**FIRCREST CITY COUNCIL  
SPECIAL MEETING AGENDA**

## STAFF REPORT TO THE CITY COUNCIL

### Alliance Residential Development Regulation Text Amendment Case # 22-03

# ALLIANCE FIRCREST PROSE

EX 5: Modified Regulating Plan Aerial Overlay

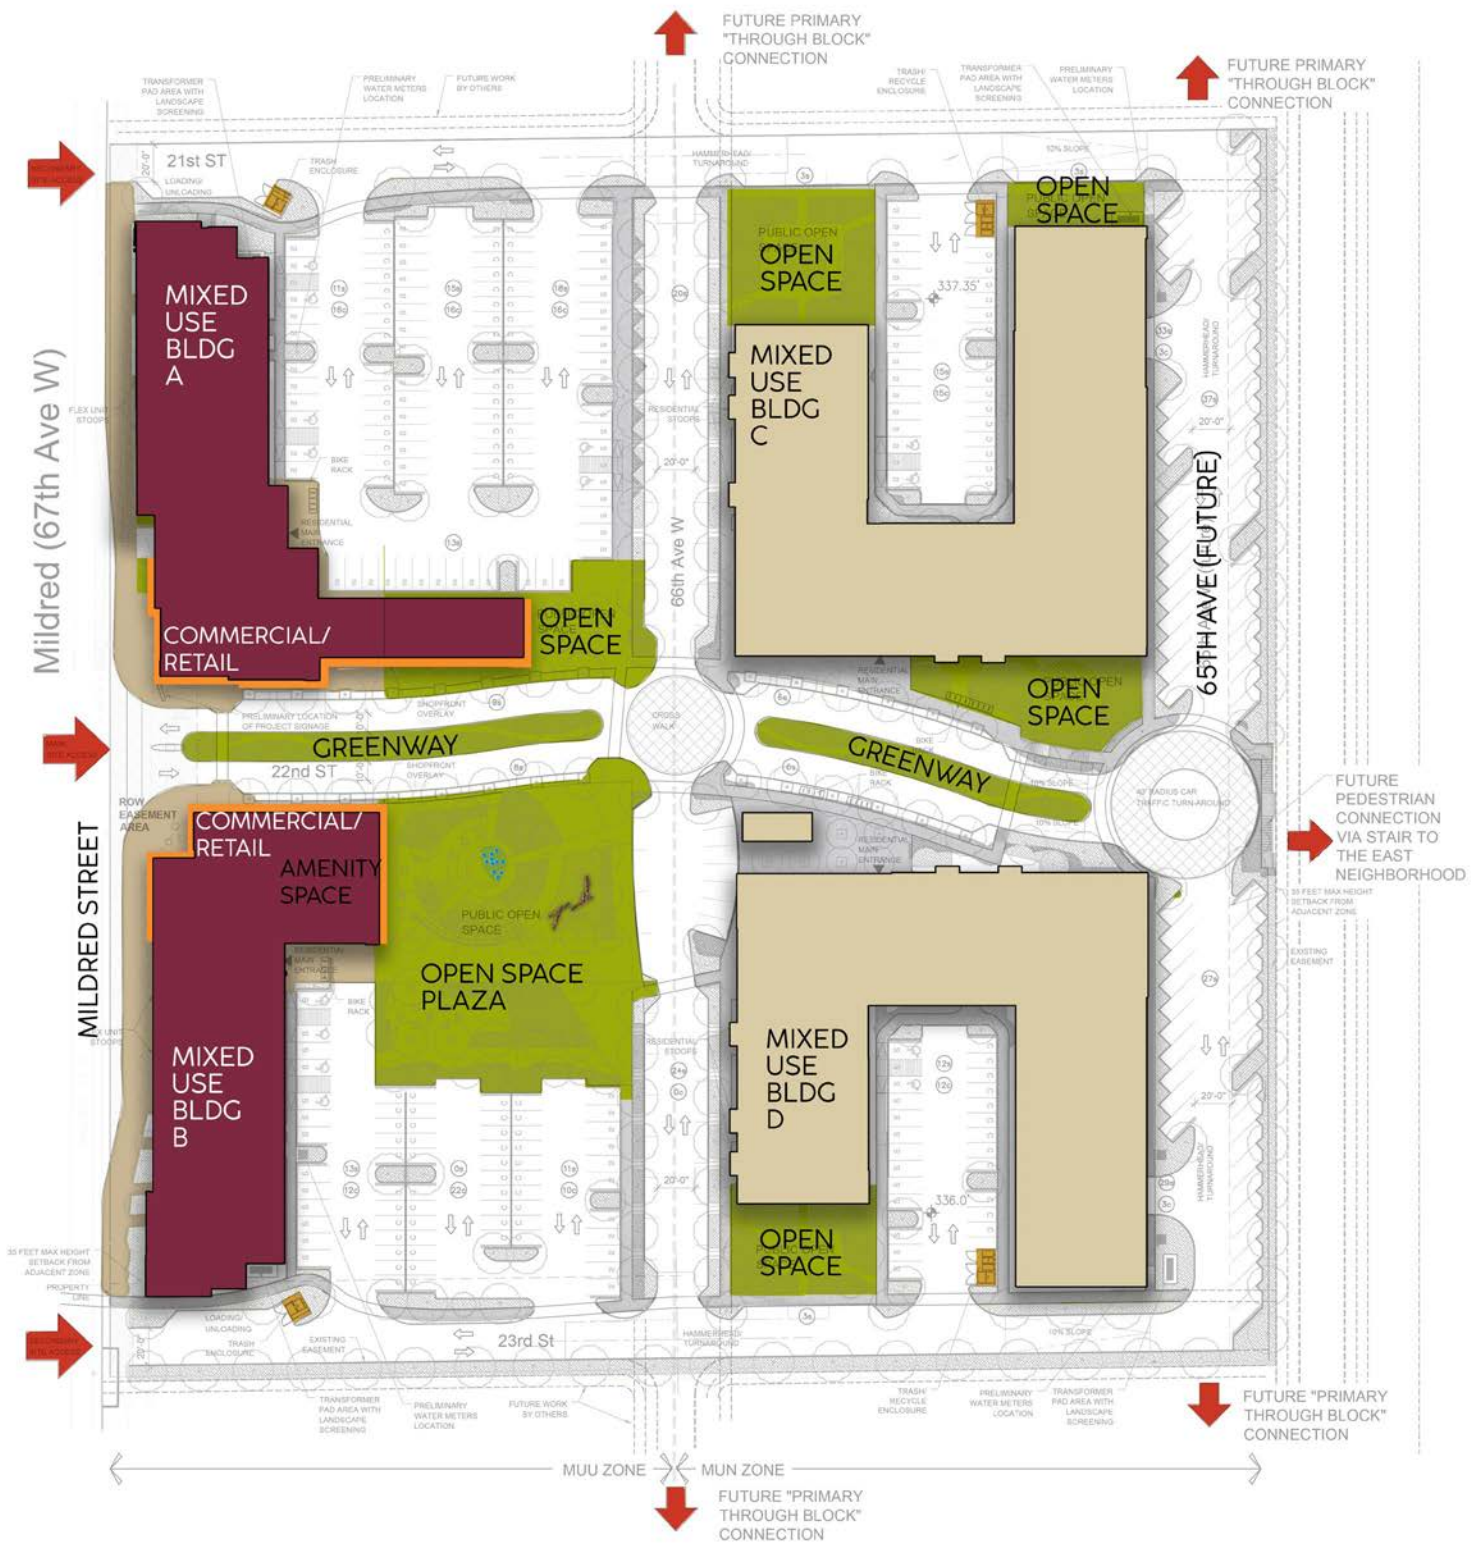
3. (08/16/2022) **Figure RP.1** – The regulating plan map (and zoning map) needs to be amended to reflect the proposed site plan for the Prose development. This would entail shifting street locations and eliminating alleys. It would also affect zoning classification boundaries.
